Responses to questions from SW-45 Cornwallis Rd Bike/Ped 2nd Community Input Meeting 11/5/2020 7:00-8:00 pm (the portions of the chat which were comments were omitted as they didn't require an answer)

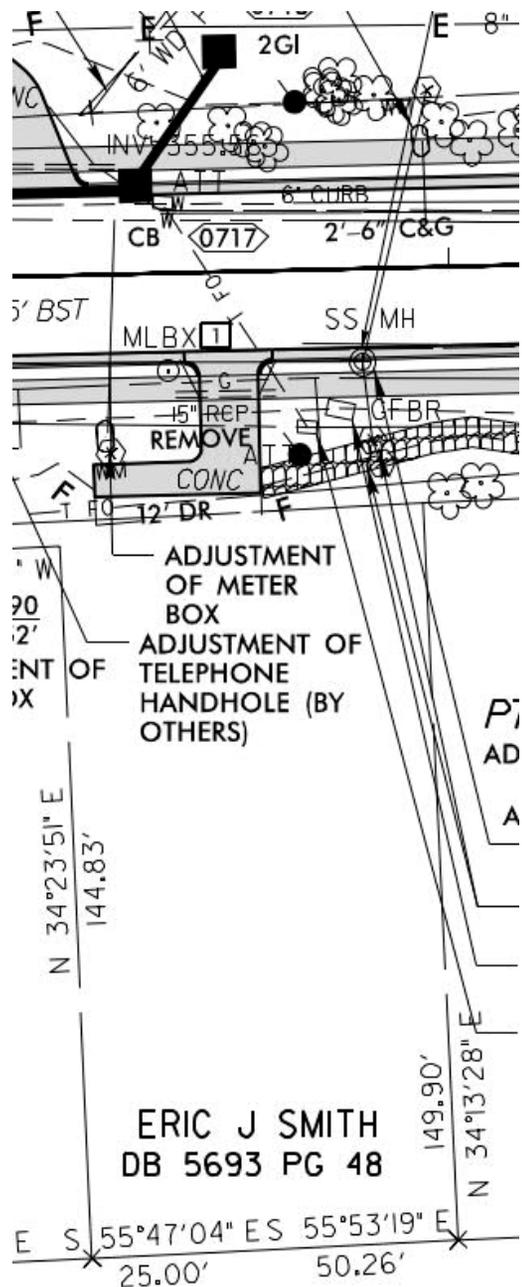
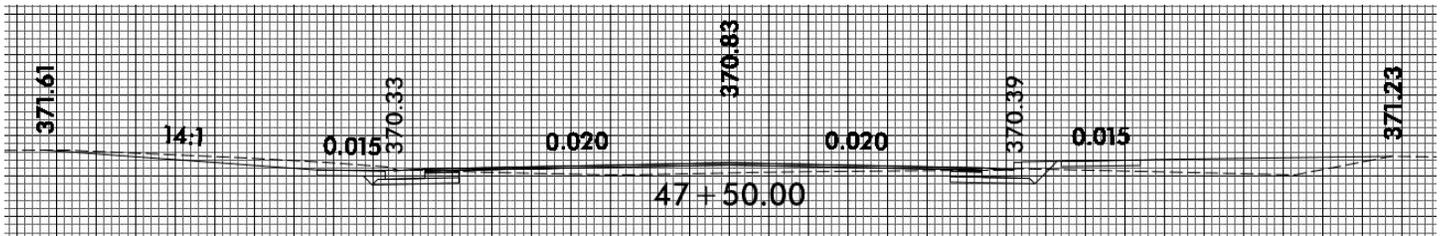
From Eric Smith : 1) My front yard is below the grade of the street. Will a retaining wall be built or is a slope going to be created? I think I would prefer an attractive retaining wall. It is likely that my yard would pool in a heavy rain event. Will my yard drain into the culvert pipe in some way? Can the city contribute toward an attractive shielding picket fence along my elevated sidewalk??

Below you will find the plan and the cross-section at your lot. The sidewalk and driveway (within the right-of-way) will be designed to slope towards the street. The contractor will work to try and alleviate any ponding if at all possible; however, as you note it may not be possible in all situations. If there is significant ponding in the right-of-way we will install a yard inlet and pipe it to the nearest stormwater system. The city most likely would not provide picket fencing and a retaining wall wouldn't really address the situation.

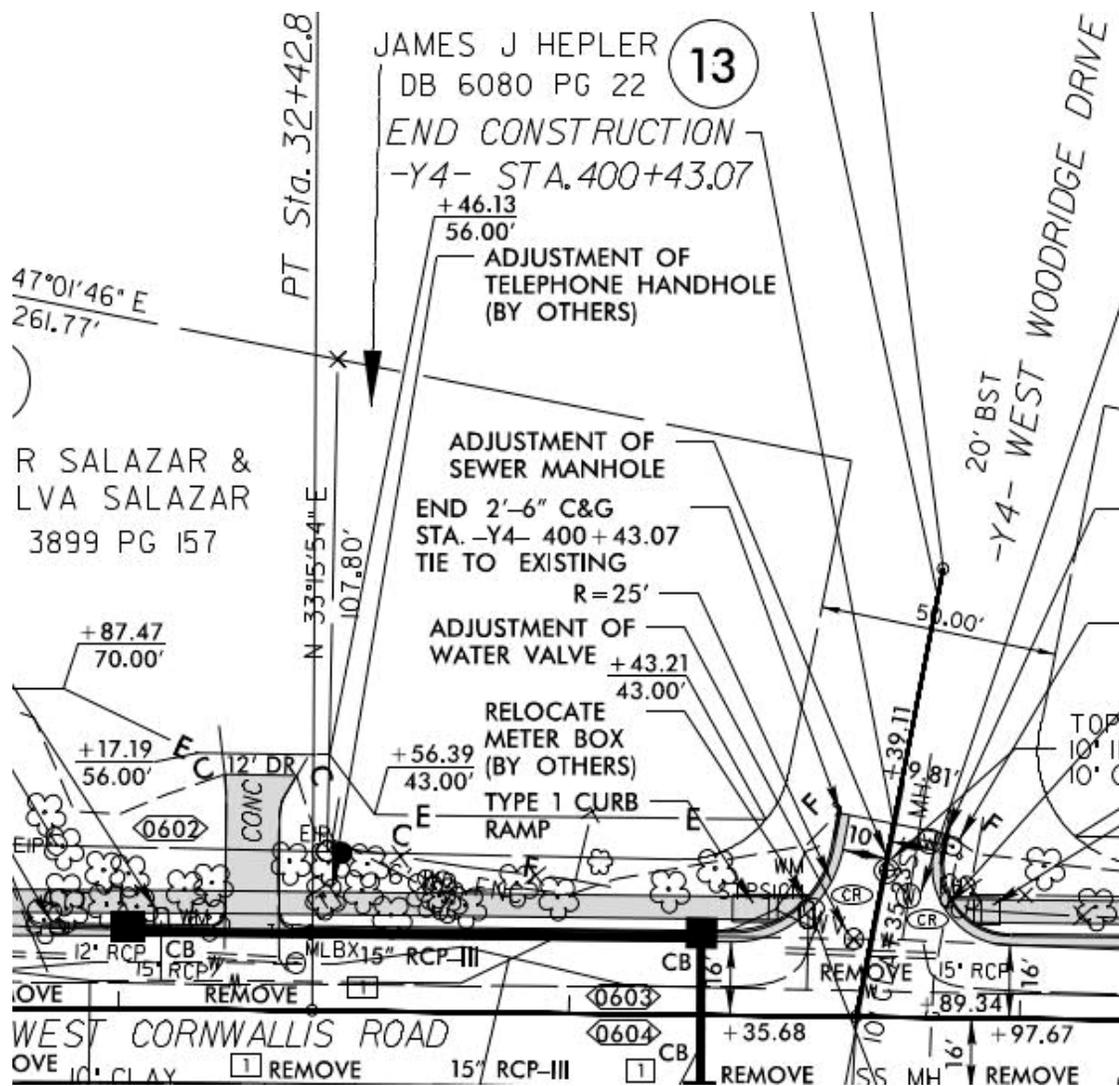
I am at the corner of University Dr. I assume that is where the easement of truck parking?

I believe when you say easement of truck parking you are referring to corners on the project where we are going to implement the design similar to the design at the southwest corner of Hope Valley Rd and University Dr where NCDOT just constructed a round-a-bout where they shortened the crosswalk distance but still allow for the larger truck turning radius by making the accessible ramp strong enough to withstand truck traffic.

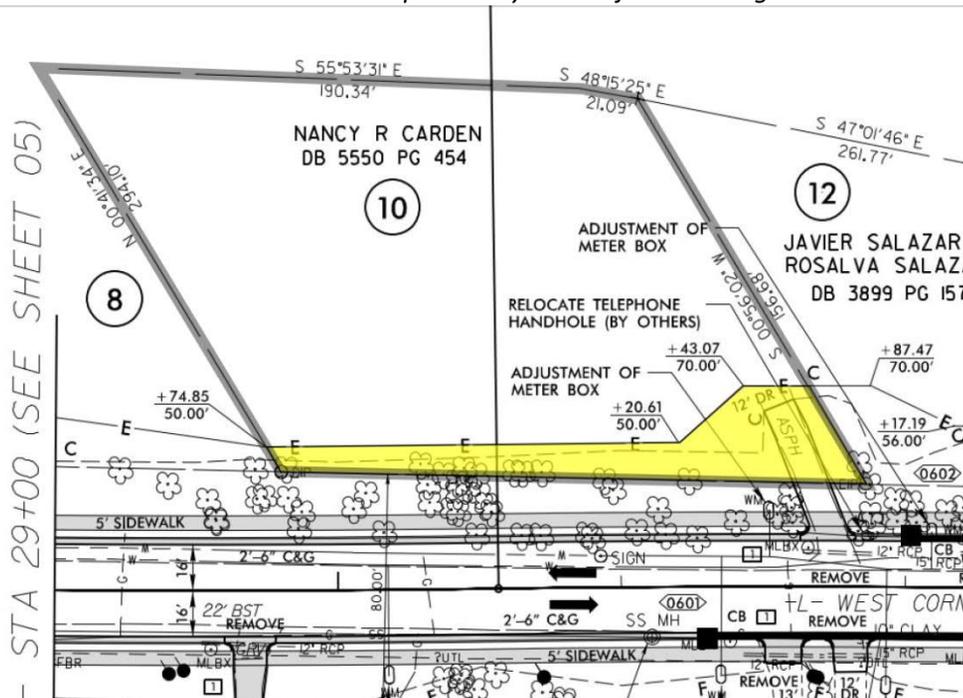
From jamie beck : I live on the corner of W. Woodridge and Cornwallis (James Hepler). It looks like the construction easement will wipe out my fence and a storage shed on my property. Could you give me an idea of how that process works? Is there compensation? I'm happy to get an answer via email.
See below an enlargement of the plans at your location. It's important to understand that the line with the "E" is the construction easement as opposed to the lines with the "C" and "F" which are the cut and fill lines. Essentially the cut and fill lines represent the extent of where we disturb the earth whereas the easement line represents area that we need in order for the men and equipment to have room to operate their equipment. As such it doesn't appear that your fence will be wiped out. I do not see your shed but the cut and fill lines do not go beyond the street right-of-way so your shed shouldn't be in the street right-of-way anyway. If the construction requires the removal of anything on your property then yes the city would compensate you accordingly.

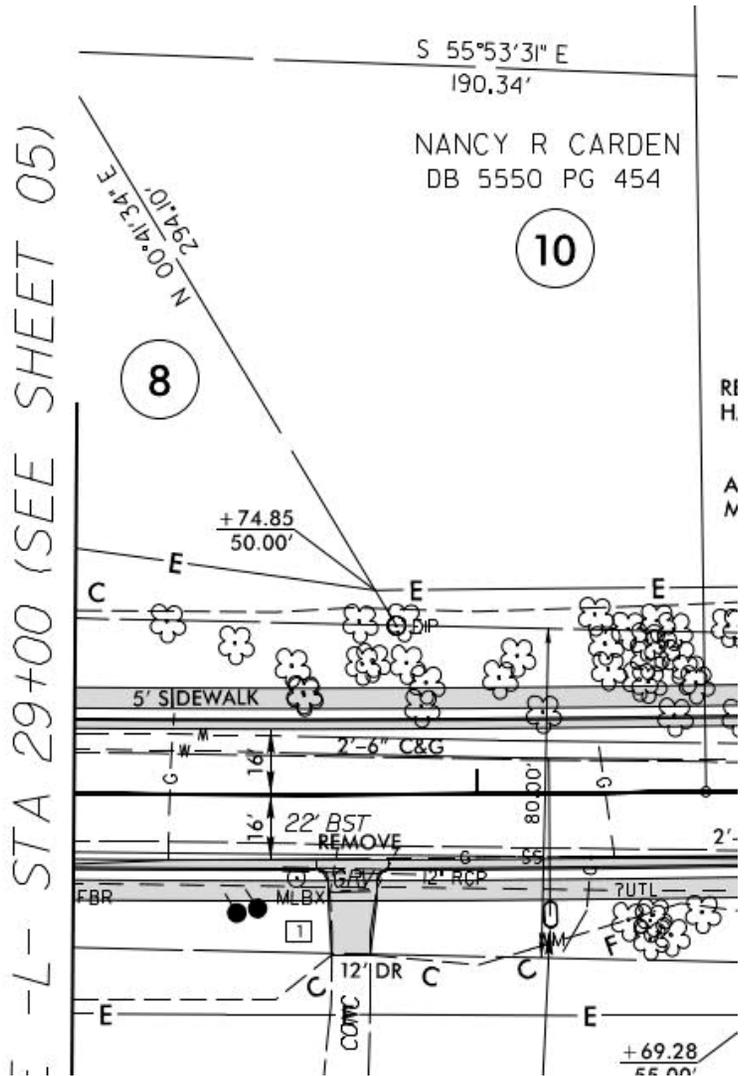
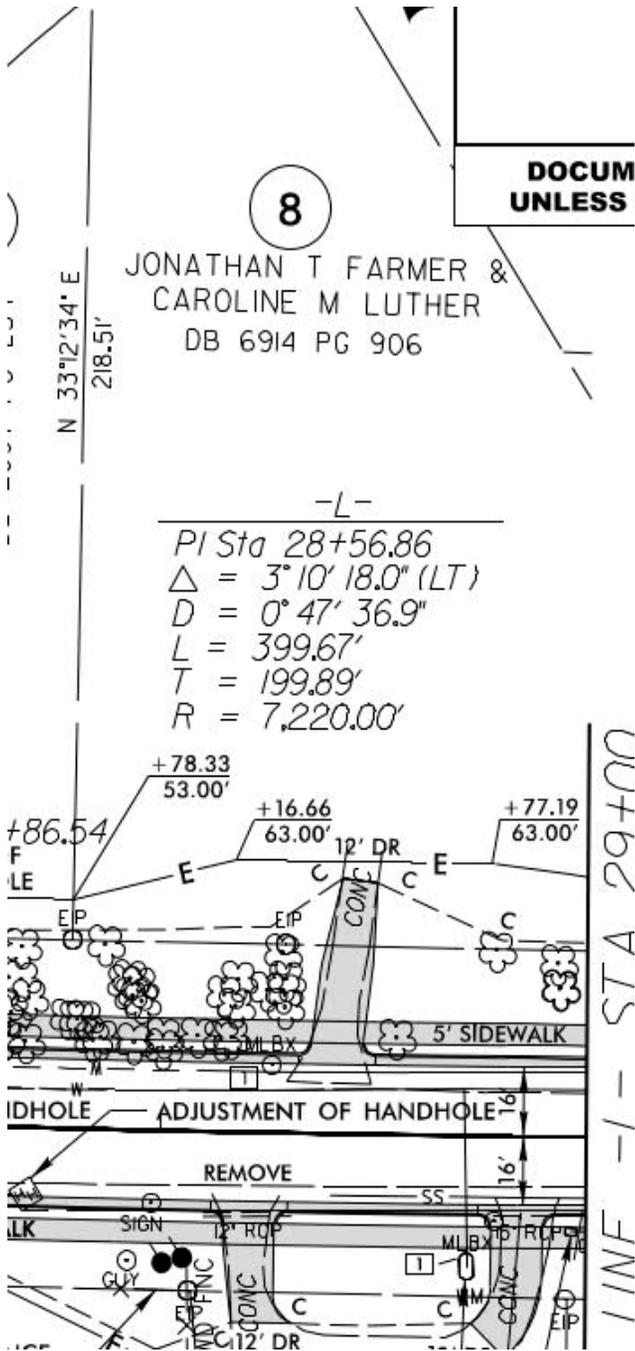
From Nancy Carden : Nancy Carden at 710 W. Cornwallis, same question. how much of my property will be included in the easement? please email the response.
In the image below the yellow represents how much of your property we will pay you for a temporary construction easement. Since these are the 65% plans they are subject to change but this should give you a good idea.
